## Product / Process Change Notification (PCN)

**PCN #:** PCN\_IndCNSW\_20180820

**Affected Series:** WE-CNSW HF size 0504

**The dimensions of the product will change as follows:**

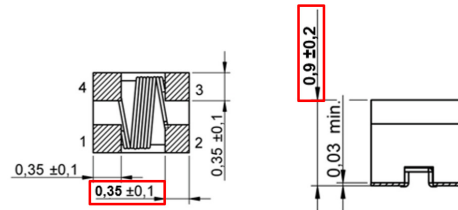
Dimensions before change

Dimensions after change
